## **THE WEST BOUNTIFUL PLANNING COMMISSION WILL HOLD A REGULAR MEETING BEGINNING AT 7:30 PM ON TUESDAY, OCTOBER 9, 2018 AT THE CITY OFFICES**

# ATWATER ESTATES

**TO: Planning Commission**

SHEET:  
**P2**

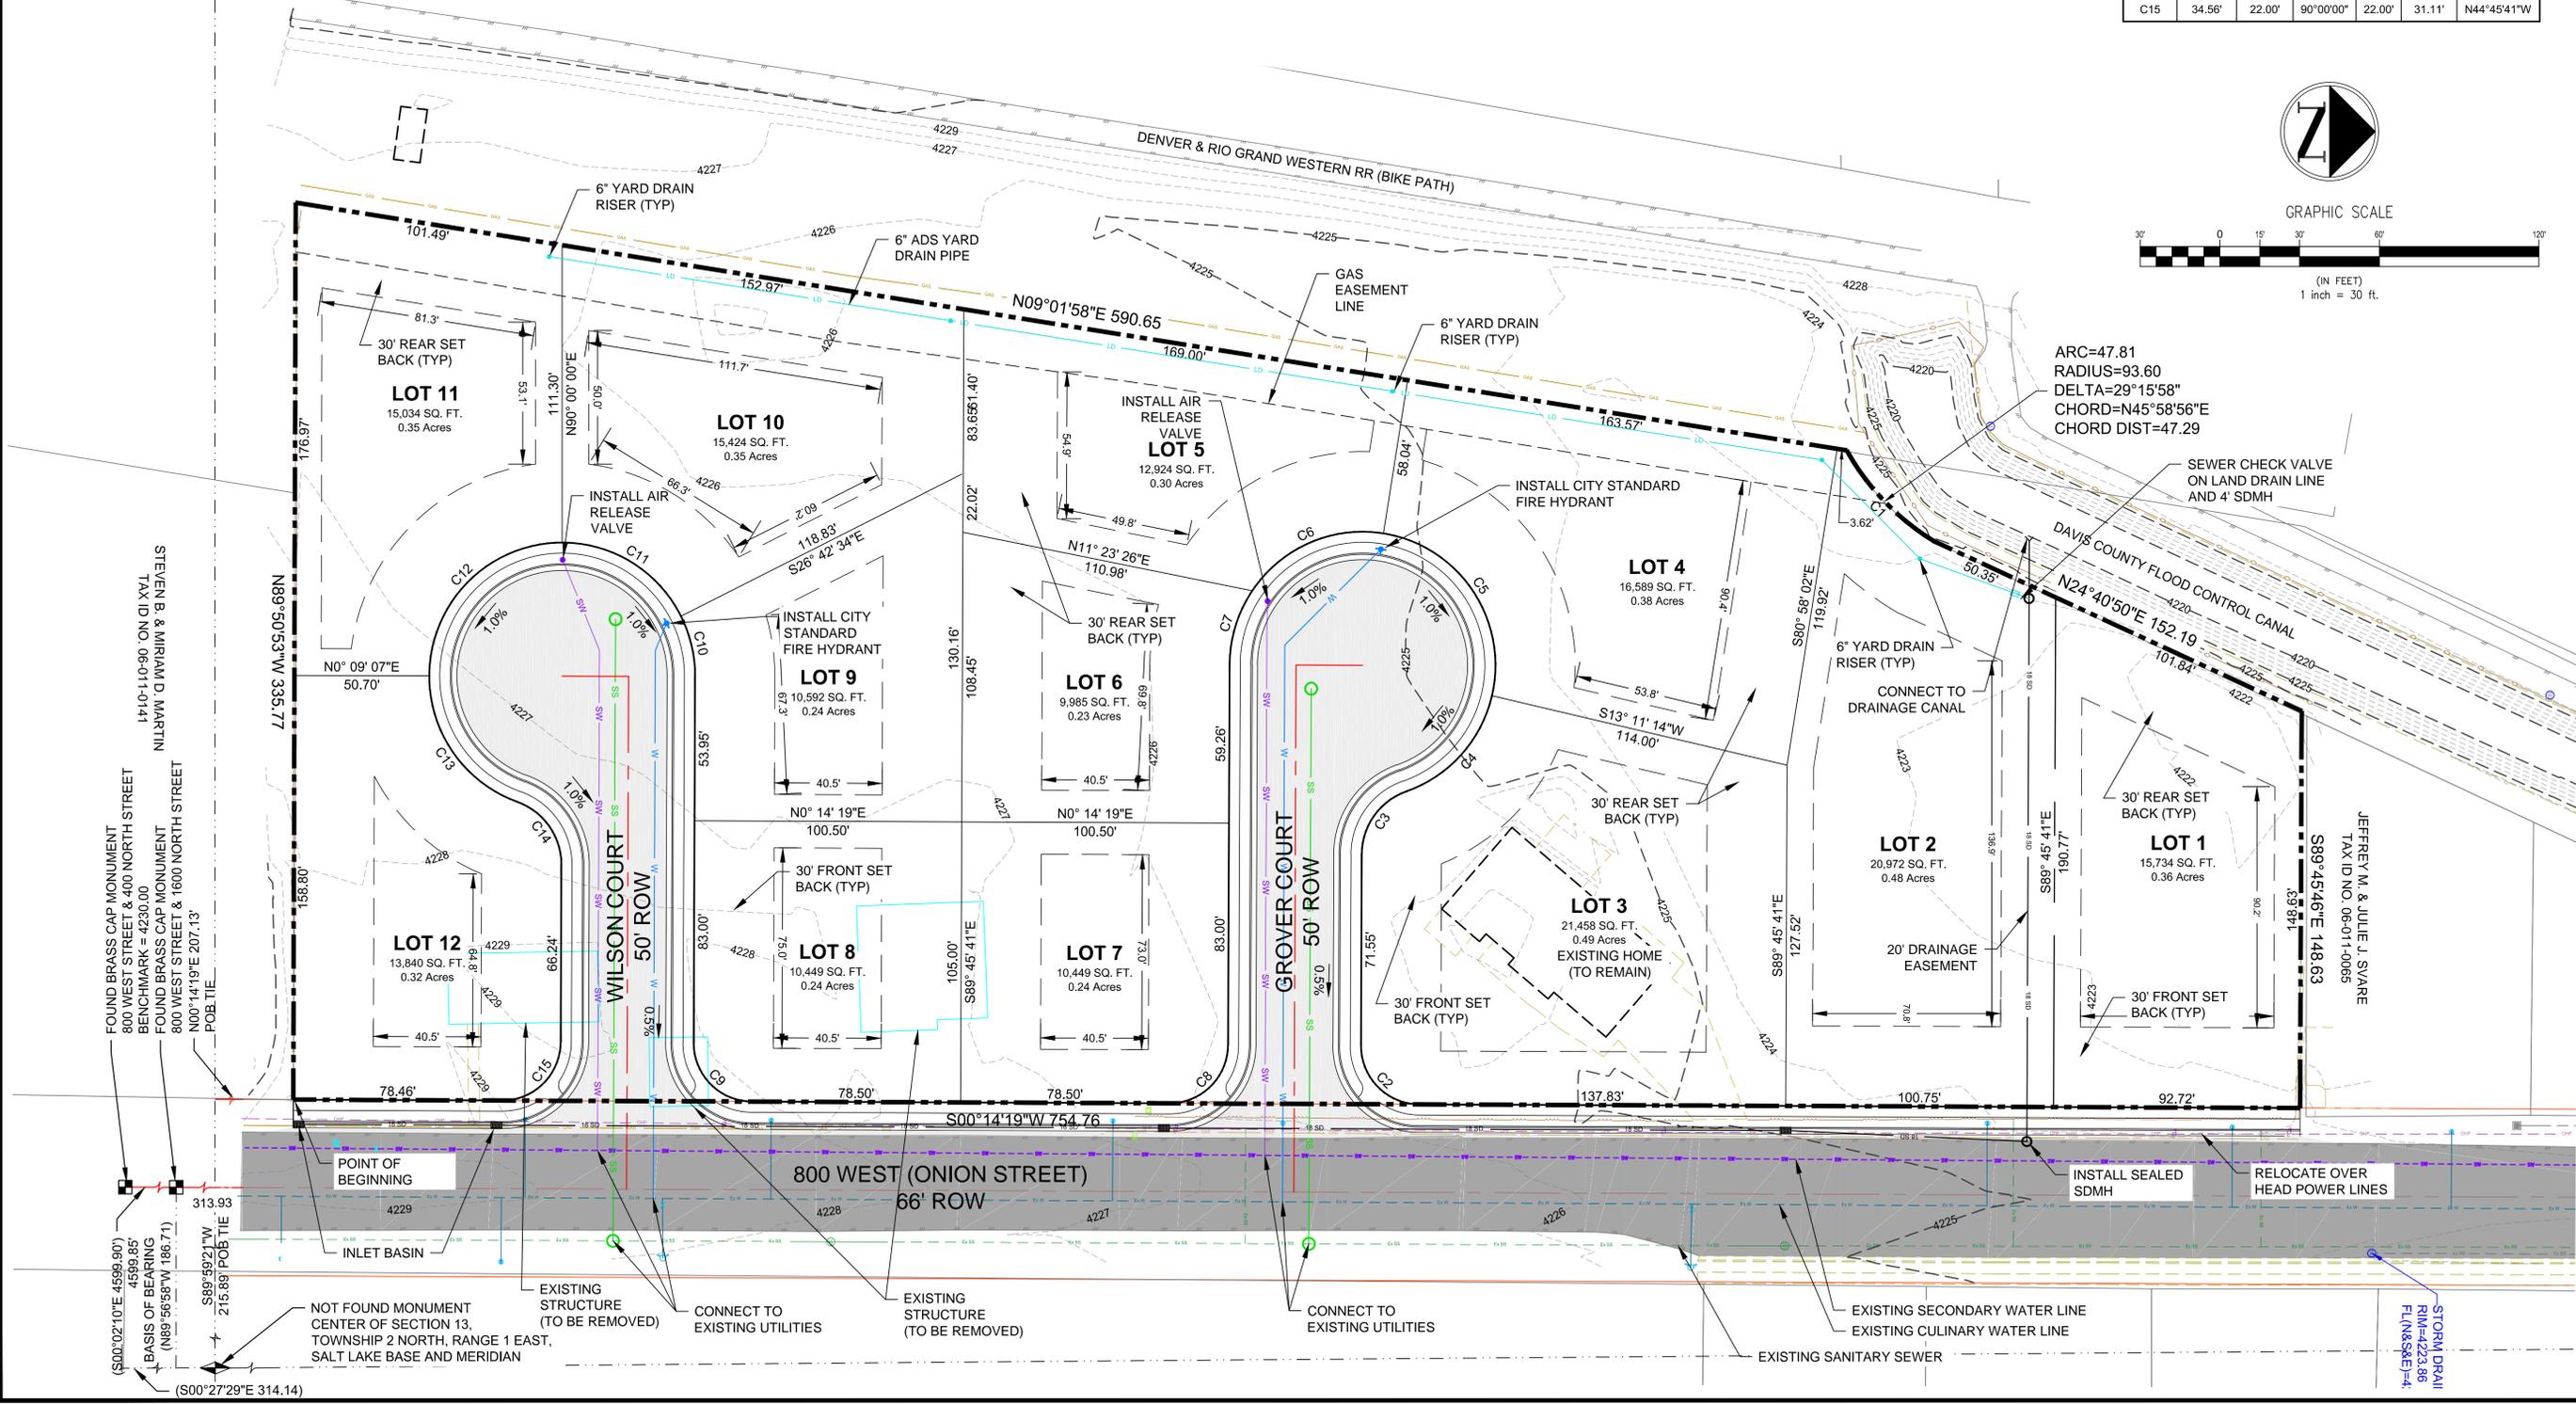
- A. A new street light toward the north side of Lot 3.
- B. County approval for drainage into DSB canal is required
- C. Street monuments are required in 800 West and in cul-de-sacs.
- D. A more detailed grading plan will be required with final plat to determine the extent of work required to connect to the existing asphalt on 800 West and final rear yard drain locations with the final plat application.
- E. Identify the desired mailbox location
